ACCESSIBILITY ASSESSMENT

February 16, 2024

ADA TITLE II ASSESSMENT

Sierra Madre Elementary School
141 West Highland Avenue
Pasadena, California 91024

Map for Barrier ID: AX424235

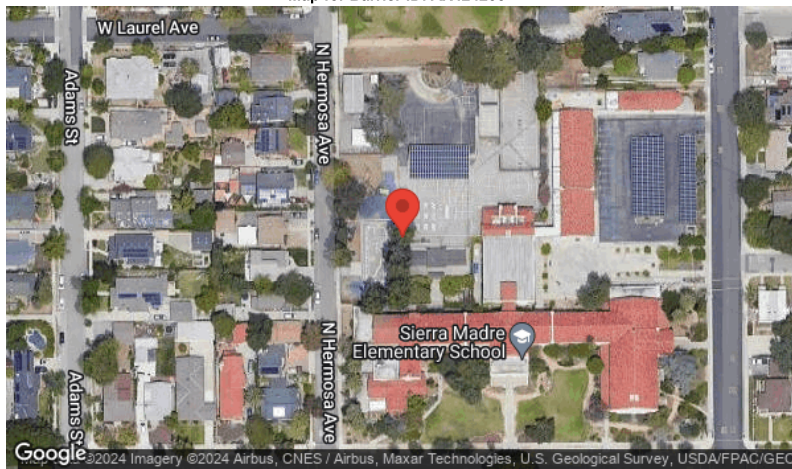
Assembly	Entrance to Building
Type	Building Entrance - Door
ADA Standard	404.2.3
Barrier Detail	The accessible door has less than 32" clear width.
Location Description	Main Entrance D-1
Observed	Dec 5, 2023 by javondrick.orange@bureauveritas.com
Site Conditions	The door clear width is 28 3/4".

Remove and replace with a door that has a minimum clear opening of 32"; measured with the door open at 90°, measured from the face of the door to the stop. Door openings shall provide a clear width of 32" minimum. Clear openings of doorways with swinging doors shall be measured between the face of the door and the stop, with the door open 90 degrees. Openings more than 24" deep shall provide a clear opening of 36" minimum. There shall be no projections into the required clear opening width lower than 34" above the finish floor or ground. Projections into the clear opening width between 34" and 80" above the finish floor or ground shall not exceed 4". [EXCEPTIONS: 1. In alterations, a projection of 5/8" maximum into the required clear width shall be permitted for the latch side stop. 2. Door closers and door stops shall be permitted to be 78" minimum above the finish floor or ground.]

Map for Barrier ID: AX424213

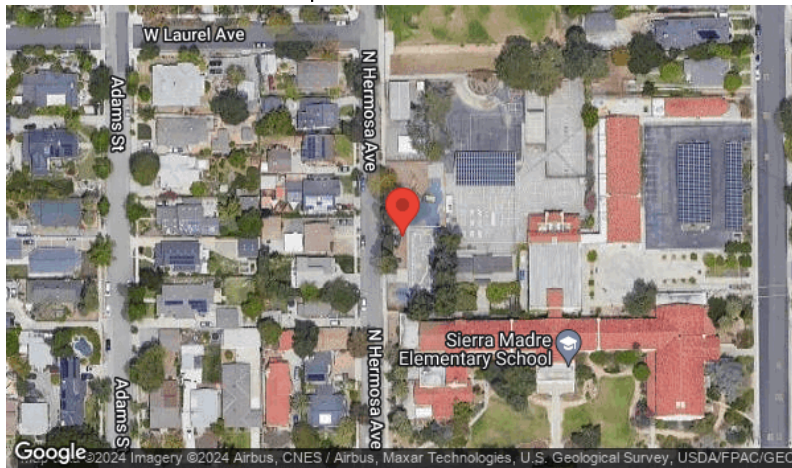
Assembly	Exterior Access Route
Type	Stairs
ADA Standard	504.3
Barrier Detail	Stairs have open risers.
Location Description	Playground 1
Observed	Dec 5, 2023 by javondrick.orange@bureauveritas.com
Site Conditions	The stairs have open risers.

Replace with compliant stairs that have closed risers. Open risers are not permitted.

Map for Barrier ID: AX424231

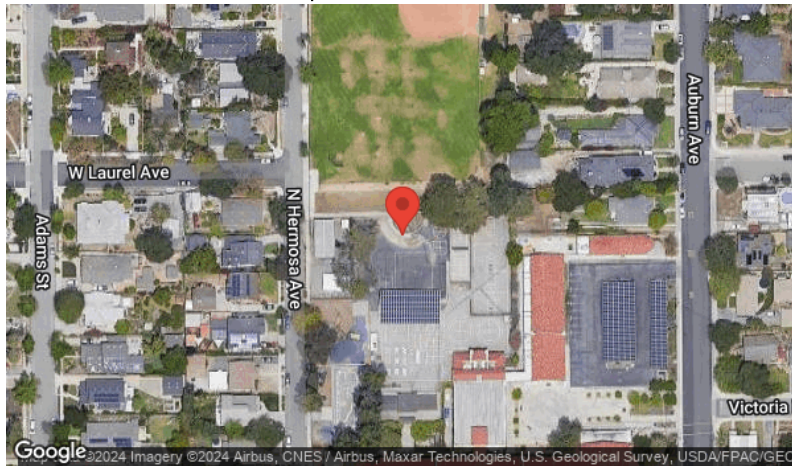
Assembly	Exterior Access Route	
Type	Ramp	
ADA Standard	California Building Code Chap 11B-405.9.2	
Barrier Detail		
CALIFORNIA: The ramp run does not have edge protection or the edge protection is not compliant.		
Location Description	Ramp R-3	
Observed	Dec 4, 2023 by javondrick.orange@bureauveritas.com	
Site Conditions	One side of the ramp does not have edge protection.	
Resolution		
Provide edge protection on the sides of the ramp runs. Compliant edge protection shall be provided on each side of ramp runs and at each side of ramp landings. A curb, 2 inches high minimum, or barrier shall be provided that prevents the passage of a 4" diameter sphere, where any portion of the sphere is within 4" of the finish floor or ground surface. To prevent wheel entrapment, the curb or barrier shall provide a continuous and uninterrupted barrier along the length of the ramp. [EXCEPTIONS: 1.Edge protection shall not be required on ramps that are not required to have handrails and have sides. 2.Edge protection shall not be required on the sides of ramp landings serving an adjoining ramp run or stairway. 3. Edge protection shall not be required on the sides of ramp landings having a vertical drop-off of 1/2" maximum within 10" horizontally of the minimum landing area.]

Map for Barrier ID: AX424087

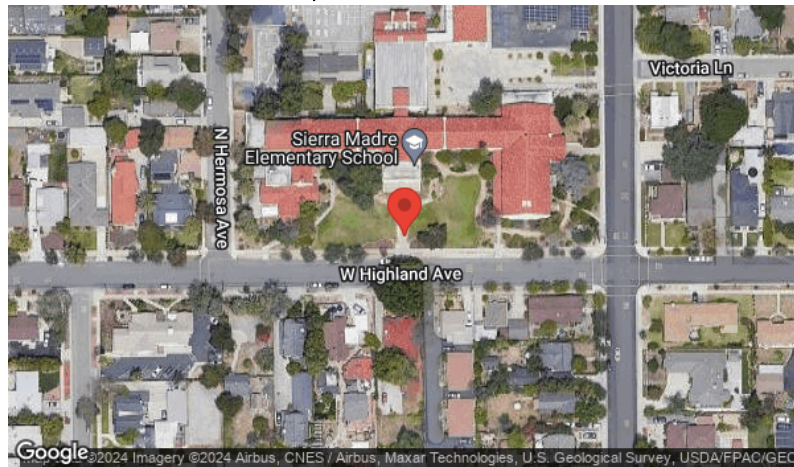
Assembly	Exterior Access Route
Type	Stairs
ADA Standard	504.2
Barrier Detail	Steps do not have uniform and compliant riser heights and/or tread depths.
Location Description	Stair ST-1
Observed	Dec 4, 2023 by javondrick.orange@bureauveritas.com
Site Conditions	The tread depths range from 12-1/2" to 13".
Tread Depth	12-1/2"

Replace the stairway. All steps on a flight of stairs shall have uniform riser heights and uniform tread depths. Risers shall be 4" high minimum and 7" high maximum. Treads shall be 11" deep minimum.. [Exterior stairs are required to be compliant where the stairs are part of a path of travel leading to designated exterior areas of refuge from the designated accessible emergency exit from the building. Existing buildings are generally required to have one accessible interior path of travel from every accessible space within the building for emergency purposes. Refer to the emergency/fire plan approved by the appropriate local authority.]

Photos for Barrier ID: AX424143

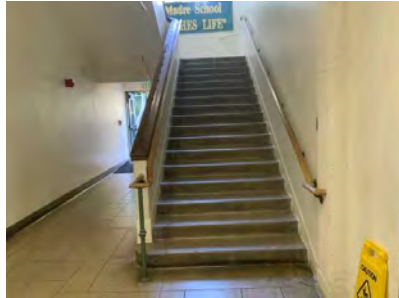
Assembly	Interior Access Route
Type	Head Room
ADA Standard	307.4
Barrier Detail	The height of the interior accessible route is less than 80" AFF.
Location Description	Toilet 158.1
Observed	Dec 5, 2023 by javondrick.orange@bureauveritas.com
Site Conditions	The height of the interior accessible route is 74 1/2".

Photos for Barrier ID: AX424123

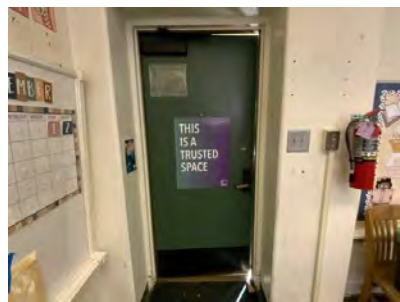
Assembly	Interior Access Route
Type	Controls And Dispensers
ADA Standard	309.4
Barrier Detail	Controls throughout the common area are not compliant.
Location Description	Workroom 110
Observed	Dec 4, 2023 by javondrick.orange@bureauveritas.com

Provide controls and operating mechanisms that are operable with one hand and not require tight grasping, pinching or twisting of the wrist and do not require more than 5#s of pressure to operate. Operable parts shall be operable with one hand and shall not require tight grasping, pinching, or twisting of the wrist. The force required to activate operable parts shall be 5 pounds (22.2 N) maximum.

Photos for Barrier ID: AX424201

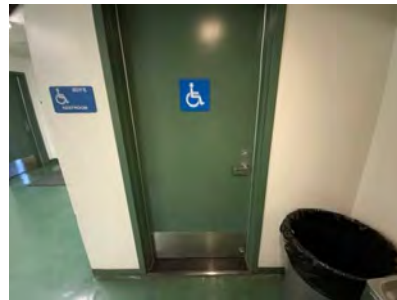
Assembly	Restroom	
Type	Protruding Object	
ADA Standard	307.2	
Barrier Detail		
The restroom circulation path is not free of objects protruding more than 4" from wall in the space between 27" and 80" height above finish floor.		
Location Description	Boys Toilet 210	
Observed	Dec 4, 2023 by javondrick.orange@bureauveritas.com	
Site Conditions		
The paper towel dispenser protrudes 6" into the circulation path at 31" above the floor.		
Horizontal Protrusion Dimension	6"	
Height Of Bottom Of Object	31"	
Resolution		
Provide a restroom circulation path which does not have objects protruding more than 4" from wall in the space between 27" and 80" height above finish floor.		
Quantity	Unit Cost	Total Cost
1 EA	250.00	\$ 250
Priority	2
